Chapter 2

Written Comments and DOE Responses

Figure 4 PTP and HFIR Flux Spectra Comparison

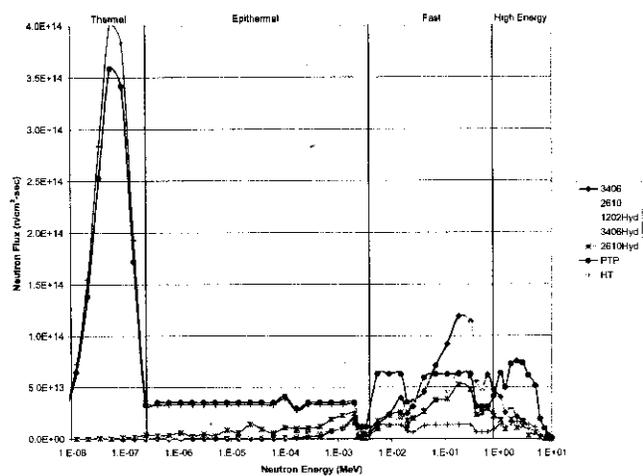
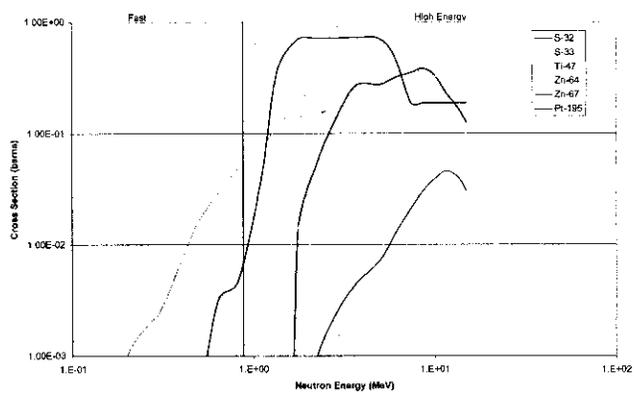
The conclusions presented in the NERAC Subcommittee for Isotope Research and Production Planning Final Report, April 2000 regarding the suitability of FFTF to produce research isotopes in a timely and cost efficient manner were made in the context of the facility producing research isotopes as its sole mission. It would not be cost effective to restart FFTF for the singular purpose of producing small quantities of various research isotopes. However, sustained operation of FFTF for the production of larger quantities of both research and commercial isotopes would be viable if operated in concert with producing plutonium-238 and conducting nuclear energy research and development for civilian applications. As the NERAC report states: "In limited instances, the DOE possesses unique resources, e.g., the high flux of fast neutrons and large irradiation volume in FFTF, that could be utilized for the production of some radioisotopes, but is best suited for commercial interests who might consider its use for isotope production." In recognition of these constraints on its operational feasibility, the NI PEIS only evaluates the use of FFTF when coupled with the other stated missions. While some existing reactors may possess the potential capability or capacity to support research isotope production, as suggested in the NERAC report, it is unlikely that reliable, increased production of these isotopes to support projected needs could be accomplished without impacting the existing missions of these facilities. As stated in the Final Report, the Subcommittee had reviewed the FFTF business plan and intended to submit their observations and suggestions in a separate document. The discussion of Iodine-131 production referred to by the commentor is not presented in the Final Report.

991-5: DOE notes the commentor's support for Alternative 1, Restart FFTF, with the use of HFIR to supplement FFTF during routine shutdown.
